RESPONSE TO ADDITIONAL REQUEST FOR ADDITIONAL INFORMATION DA/2019/1190

We write to you on behalf of the Manly Warringah Sea Eagles (MWSE) as the applicant to DA2019/1190 which seeks consent for the construction of a new grandstand and centre of excellence (COE) on the northern end of Brookvale Oval, located on Pittwater Road, Brookvale.

Figure 1 Existing Shadows from trees throughout day at mid-winter

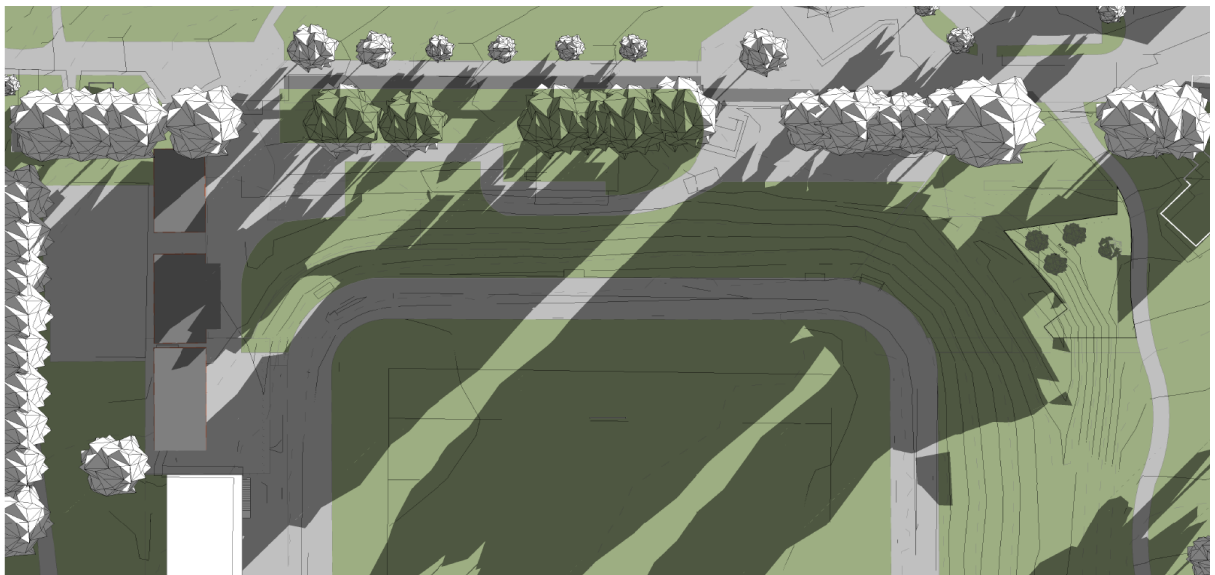
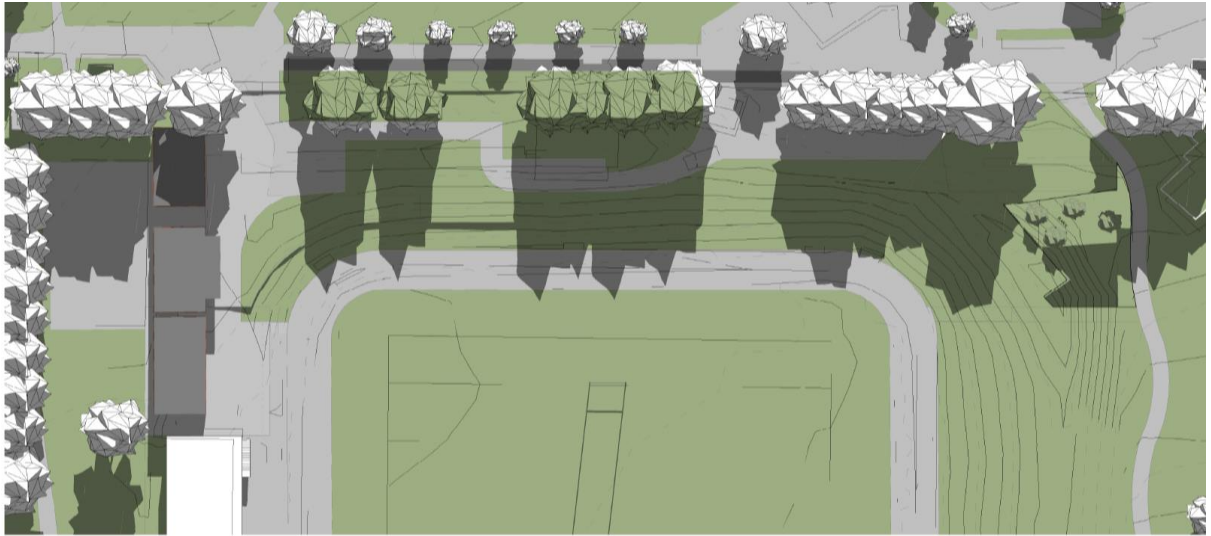
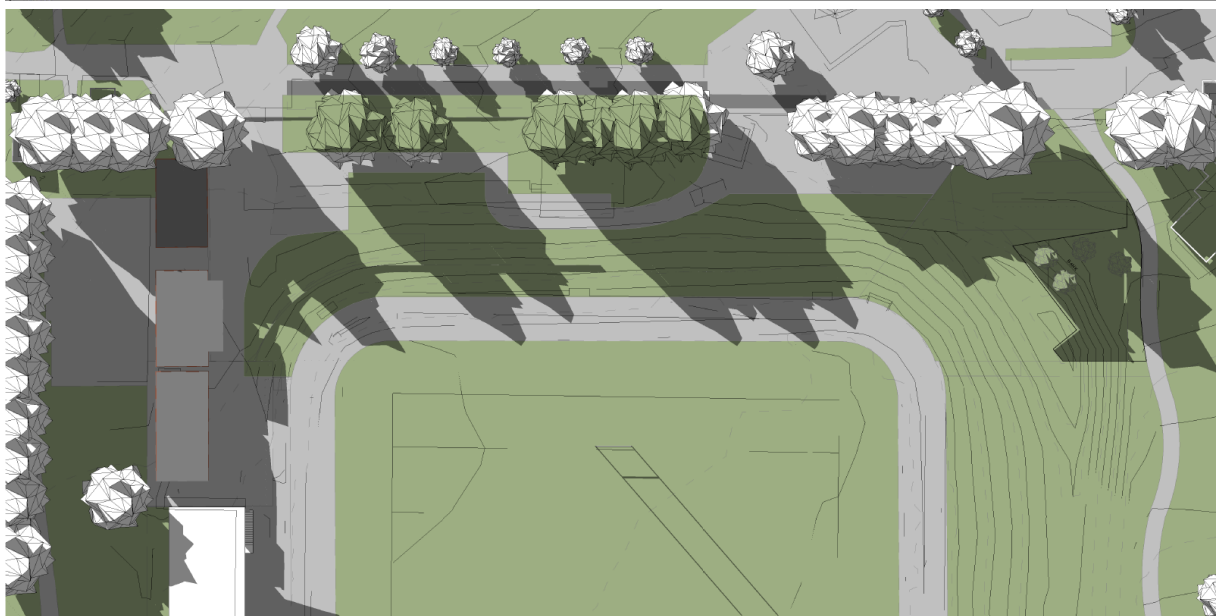
The increased concentration of solid shadow from the built form upon the northern end of the playing surface from the 20m line northward to the in-goal and runoff area will be impacted over and above its current levels of shade from the existing trees. This will impact upon the quality of the playing surface unless increased maintenance activity is undertaken and budget expenditure by Council is increased, or an alternative turf is used to produce a high quality playing surface.

The applicant has liaised with the current Turf Consultant (SportsEng) who manages the maintenance of the field. SportsEng did not provide concern at the changes to shadows on the field which will result from the proposal, noting only to ensure the roof sheeting which is utilised is as transparent as possible. While some UV is filtered when transmitting through the material, primarily for enhanced spectator viewing, not all UV is filtered out. The material proposed to be used, as previously confirmed, is one of the most common used on stadiums throughout Sydney and globally.

It is however important to review the specific impact which will result from the proposal, noting that shown below is a 'worse case' scenario at a time during the year when there is very little UV radiation to begin with.

Figure 1 demonstrates the current shadow impact from the existing vegetation on site. It is important to note that current impacts on the turf exist throughout the day.
